McKinney Independent School District, TX
Procurement
Laura Duree, Director of Purchasing
1 Duvall St, Mckinney, TX 75069
(972) 542-7410

QUESTION & ANSWER REPORT

RFP No. 2026-10-652

E-RATE CATEGORY 2

MCKINNEY BOYD HIGH SCHOOL FLOOR 1:

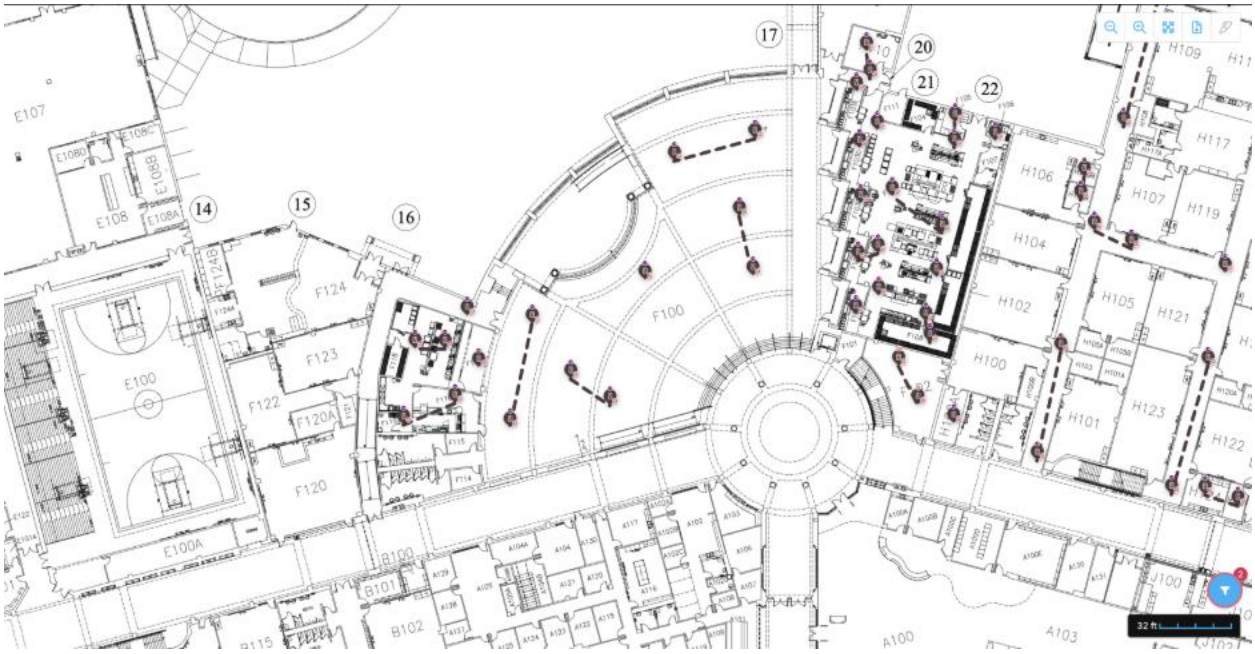
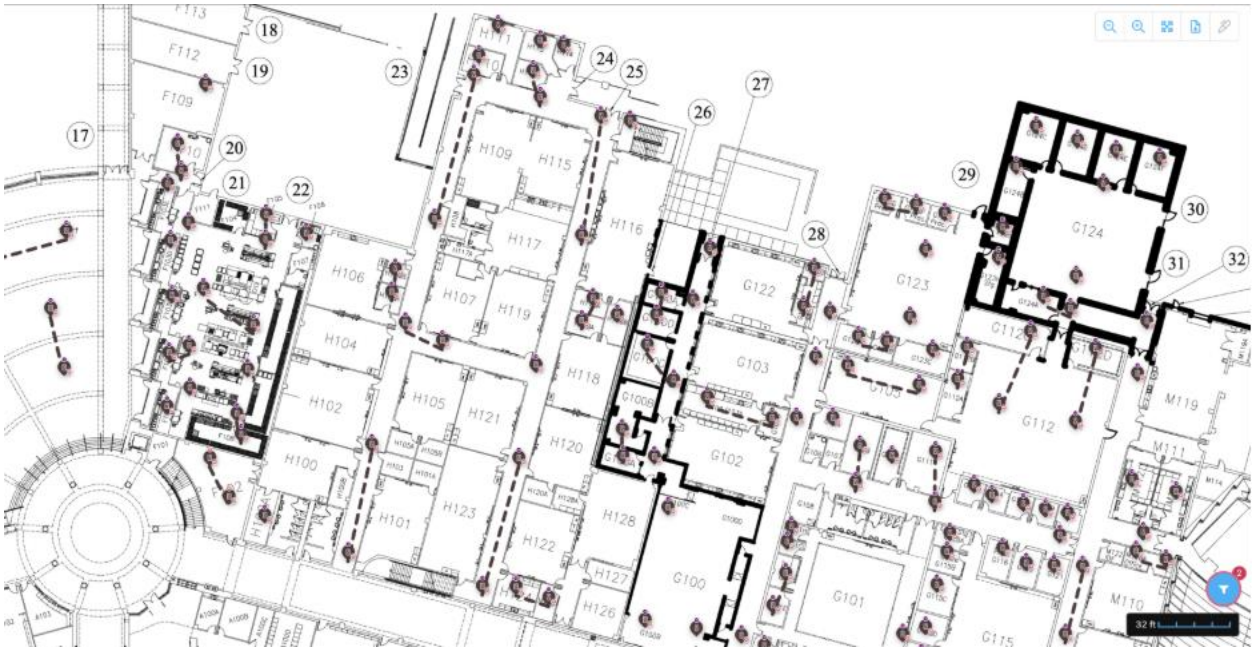
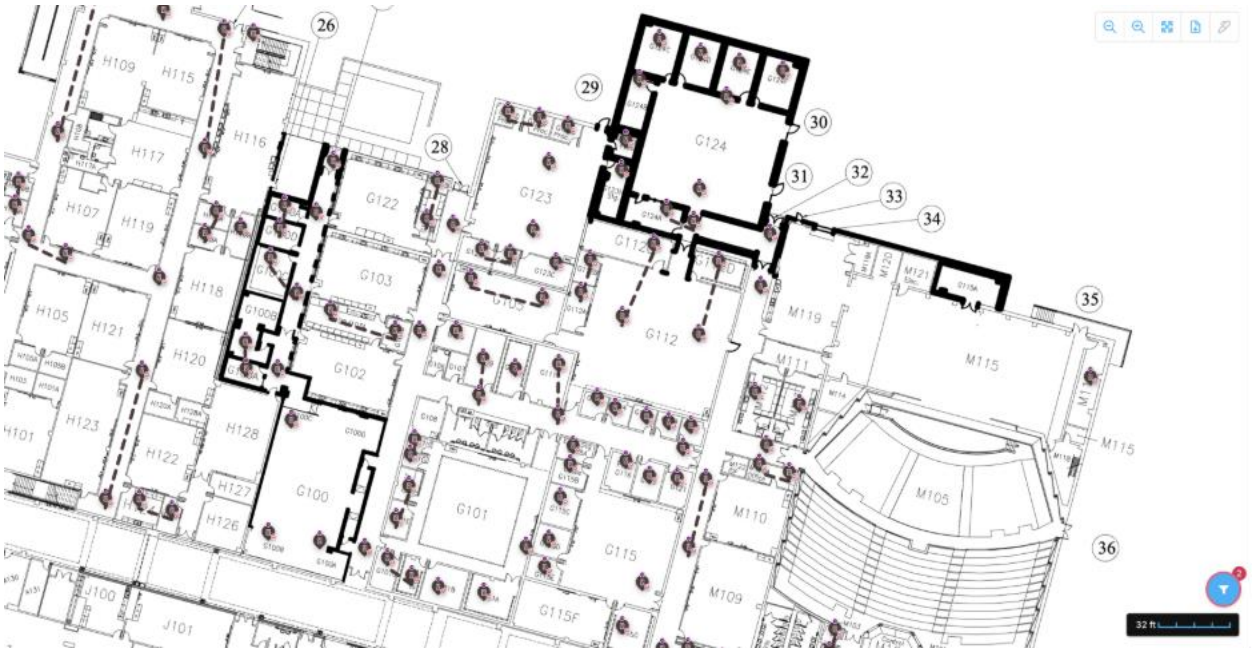
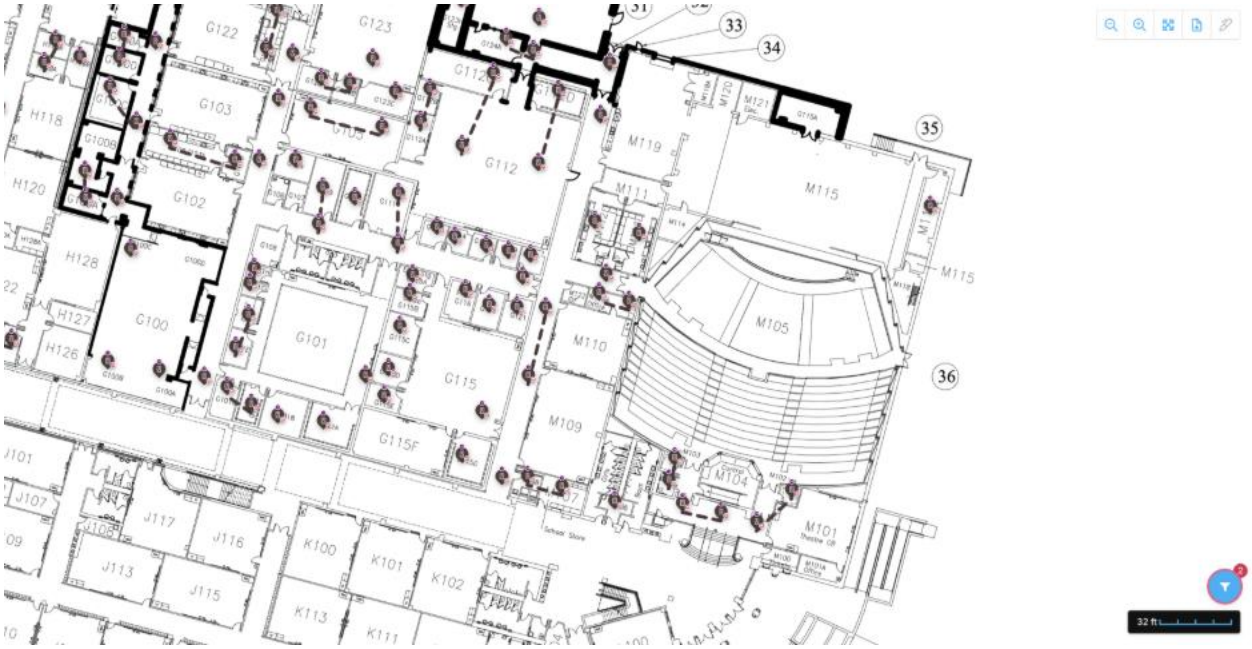
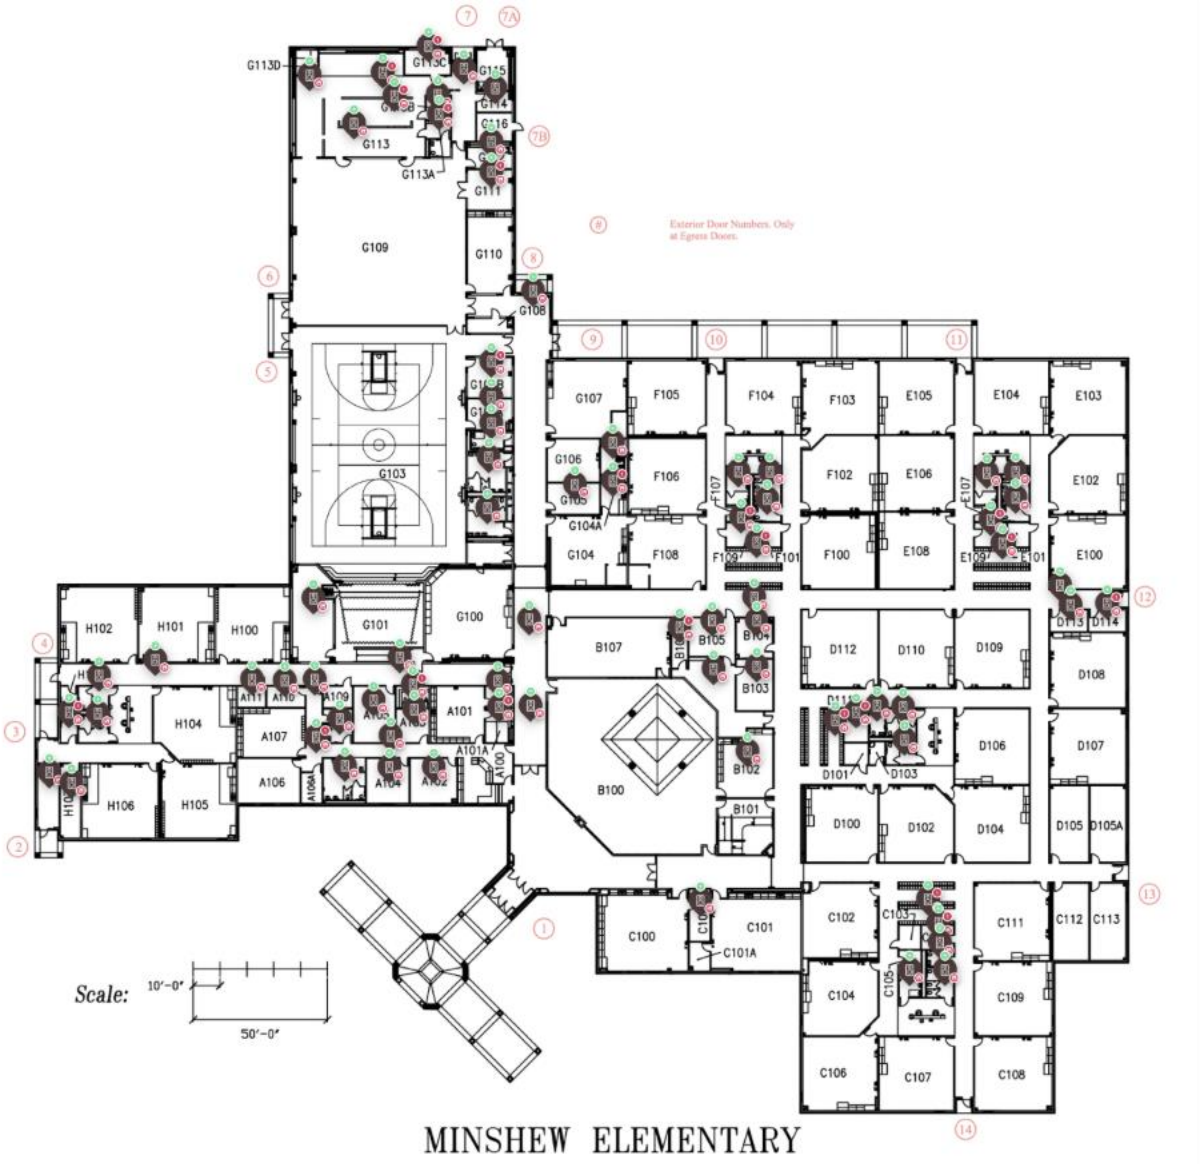
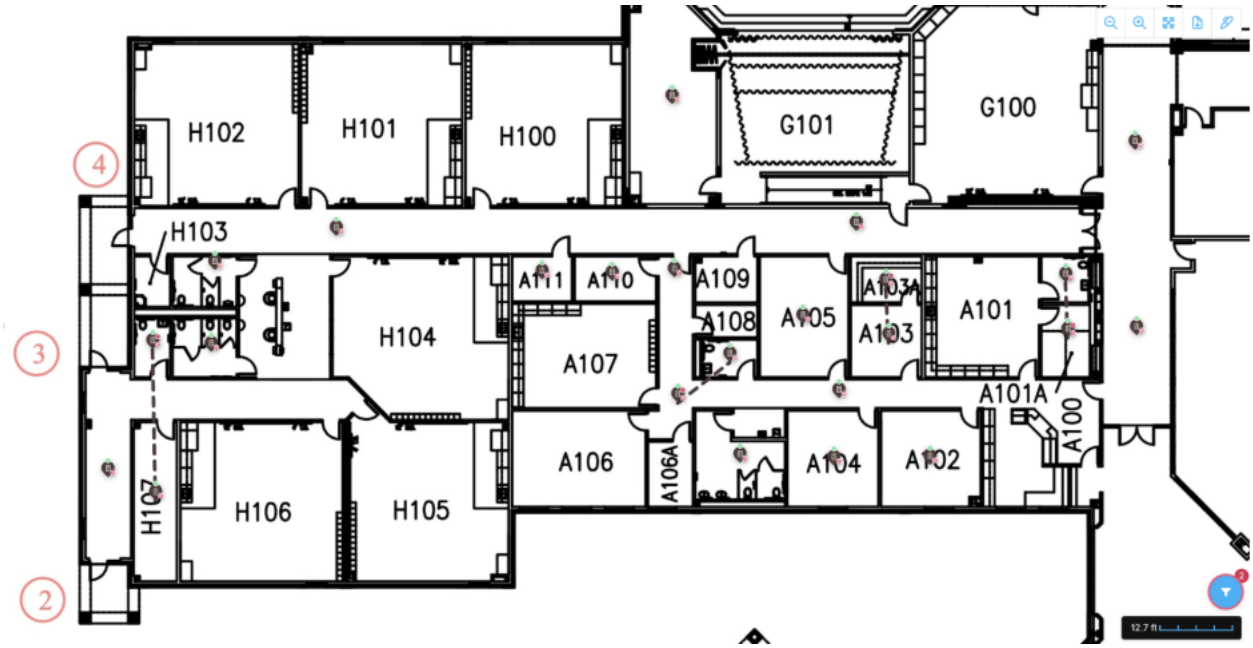
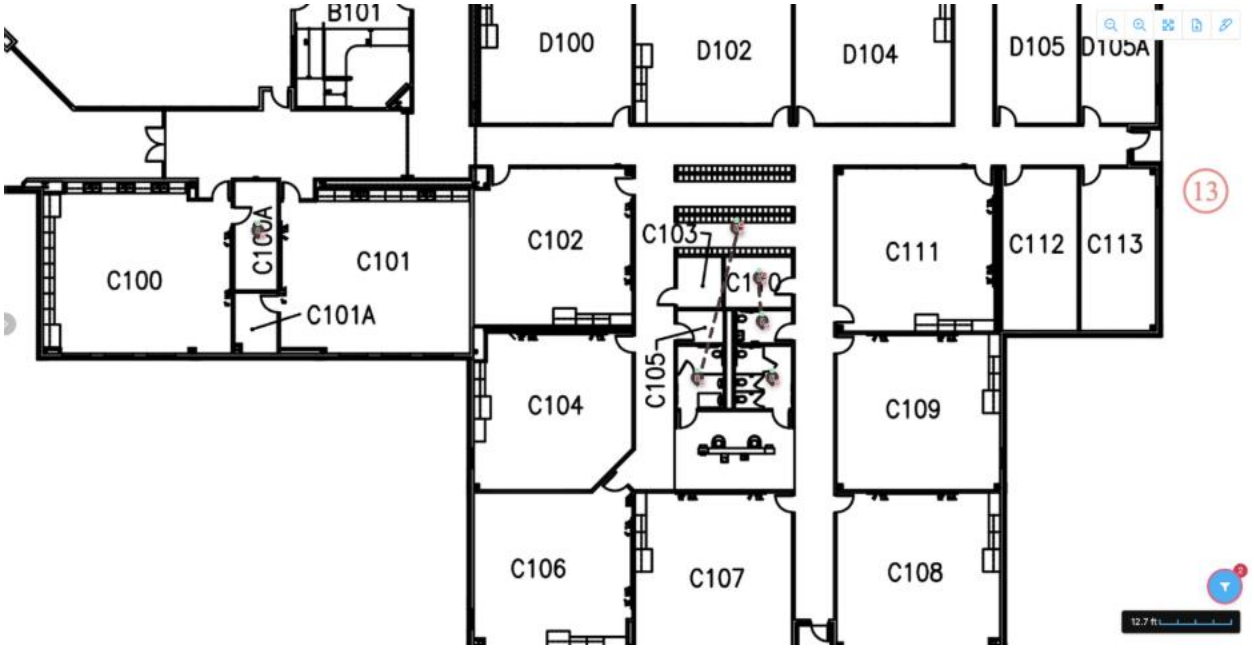
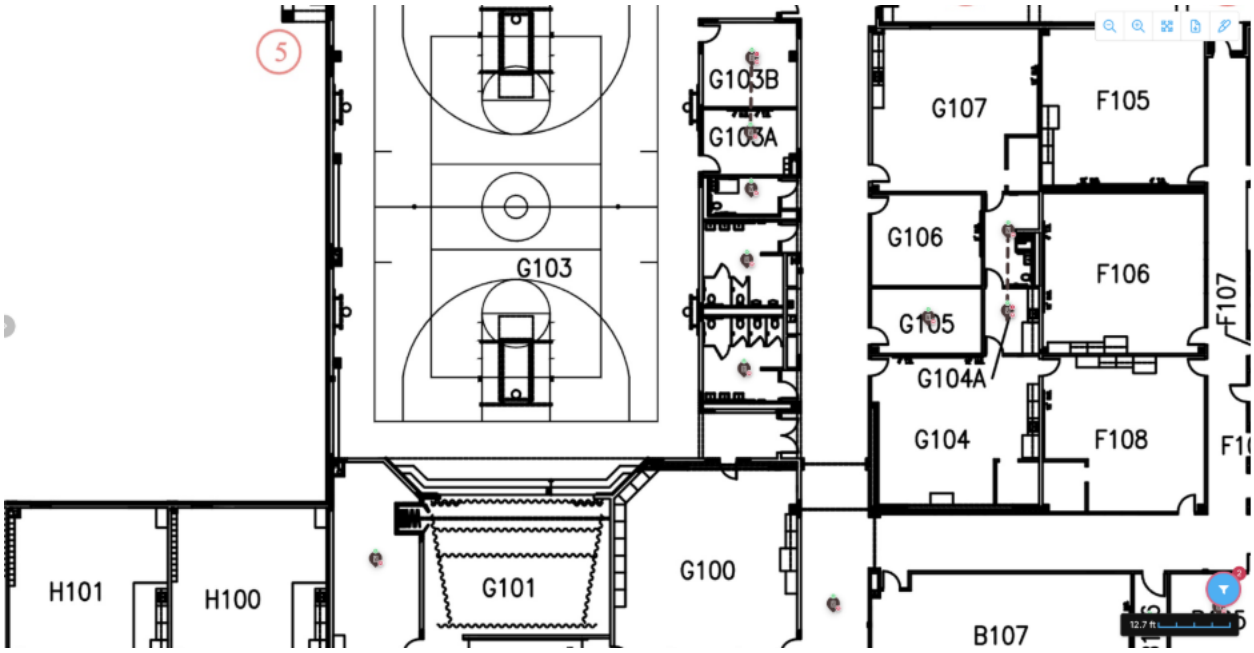
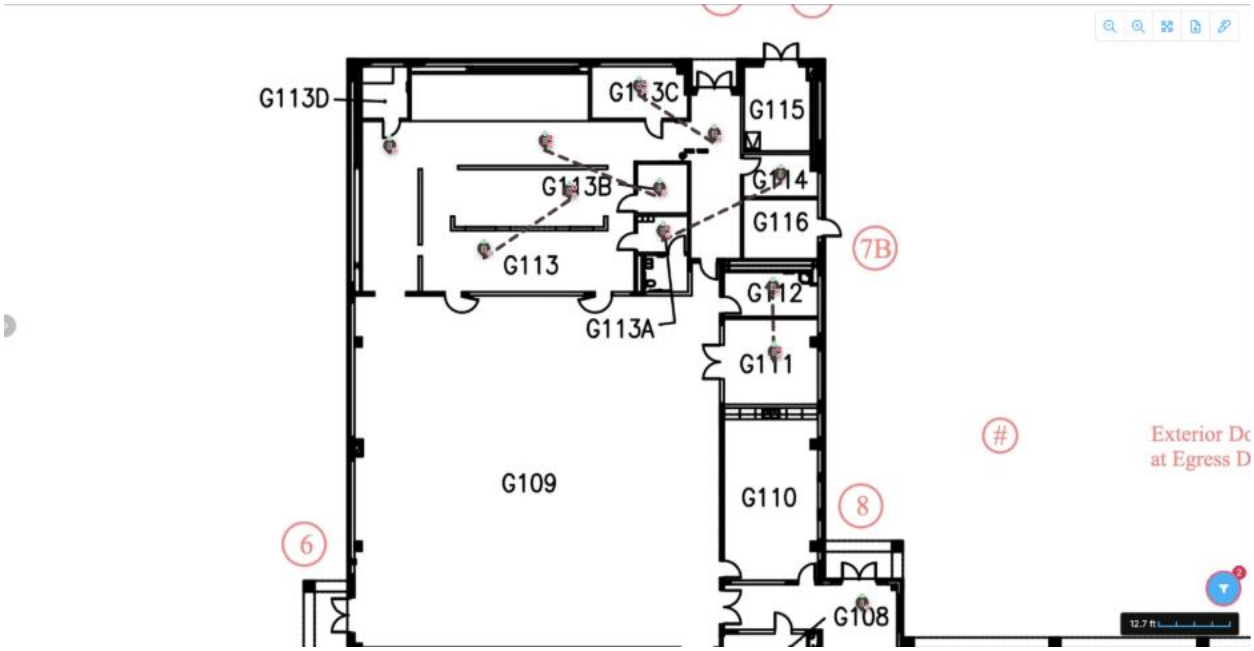
Question: Page 41 installation specifications indicates we are to run 18/2 between extension speakers and close IP ceiling speakers. Please provide drawings indicating the Extension Speakers and close IP ceiling speaker locations, or provide an estimated distance for cable & supports allocation.

Answered by Laura Duree: The speaker & extension speaker locations will be provided in an addendum.

MCKINNEY BOYD HIGH SCHOOL FLOOR 1

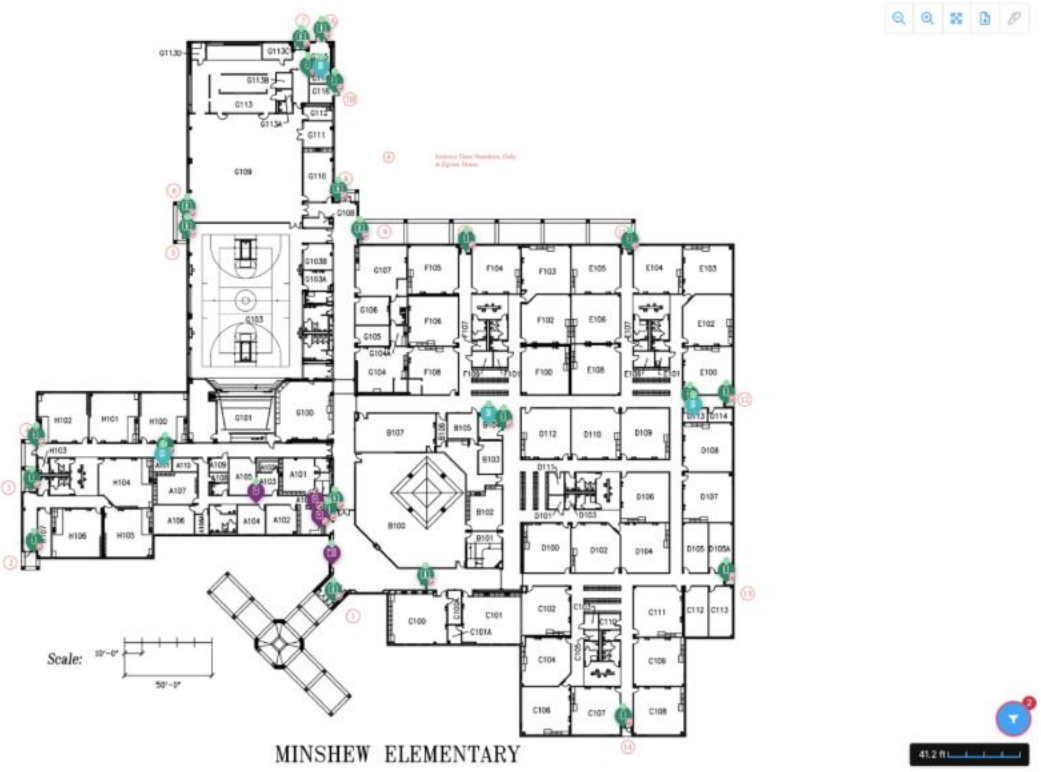
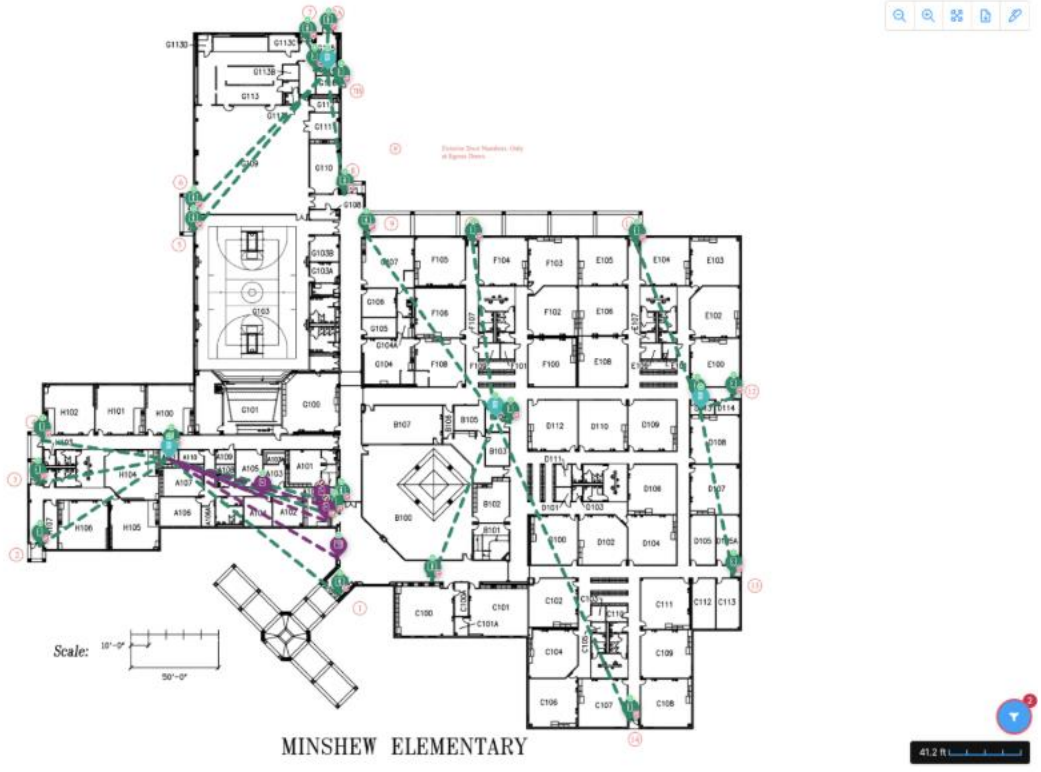
Question: Page 41 lists items to support Badge Readers, DPI Sensors and Lockdown buttons. Please provide drawings indicating their end device locations, or provide and estimated distance for Cable & Supports allocation.

Answered by Laura Duree: Badge readers, DPI Sensor, & Lockdown Button Locations will be provided in an addendum.

MCKINNEY BOYD HIGH SCHOOL FLOOR 1:

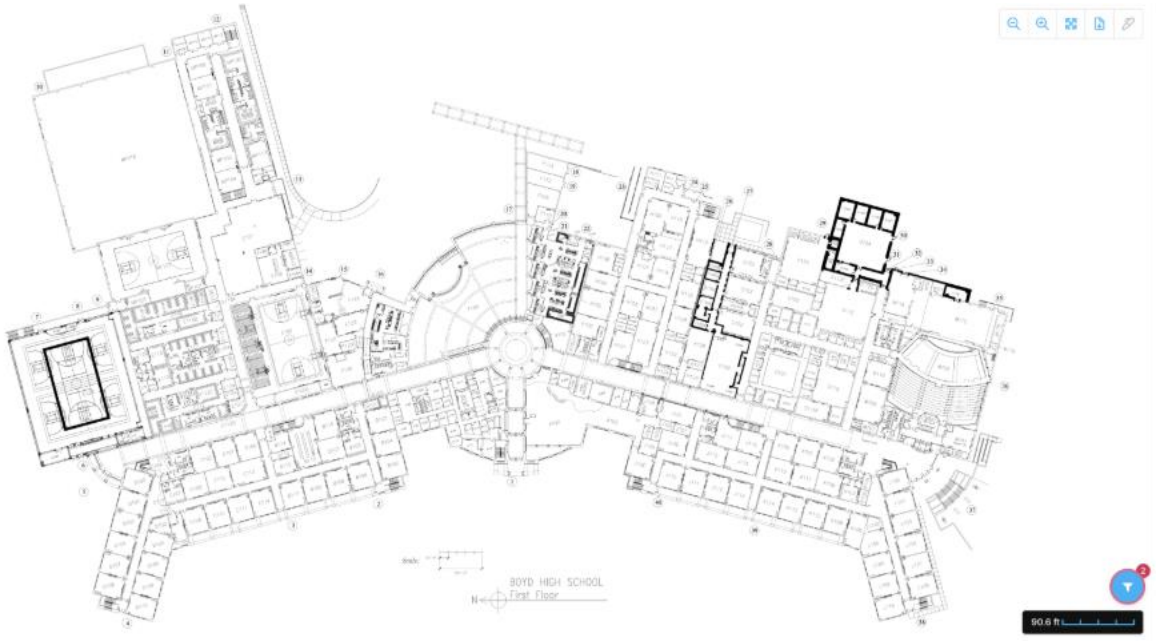
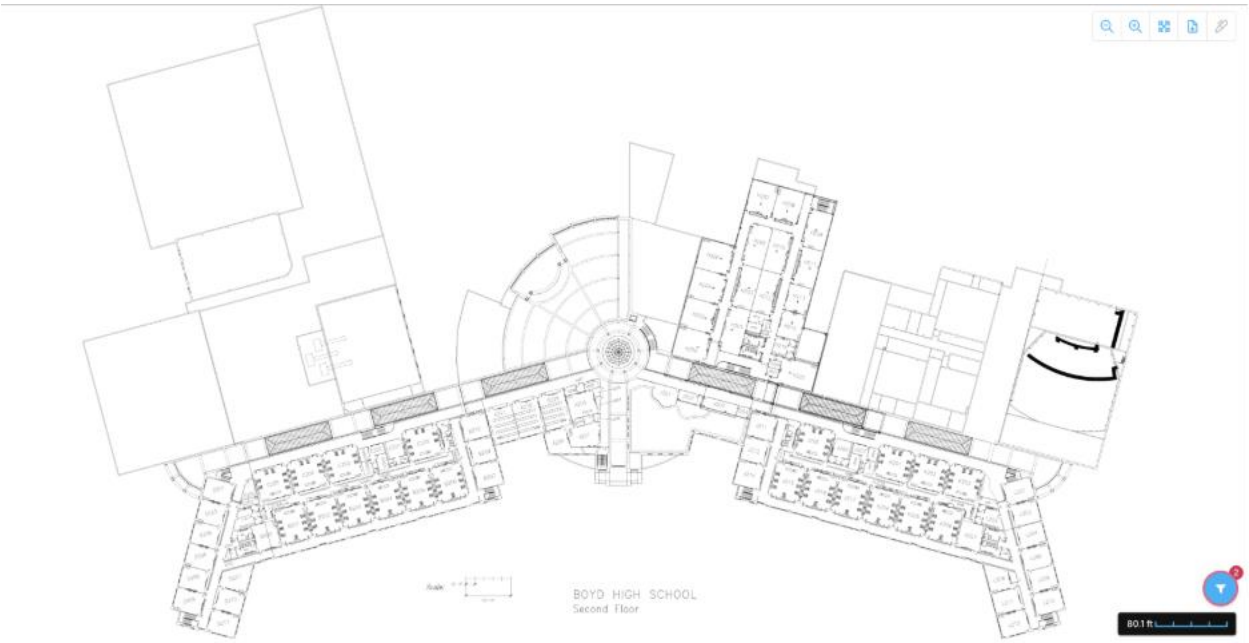
Question: Can you provide a to-scale overall drawing for each floor at Boyd HS to accurately calculate backbone fiber footages?

Answered by Stephen McGilvray: Refer to the addendum section: FLOOR PLANS
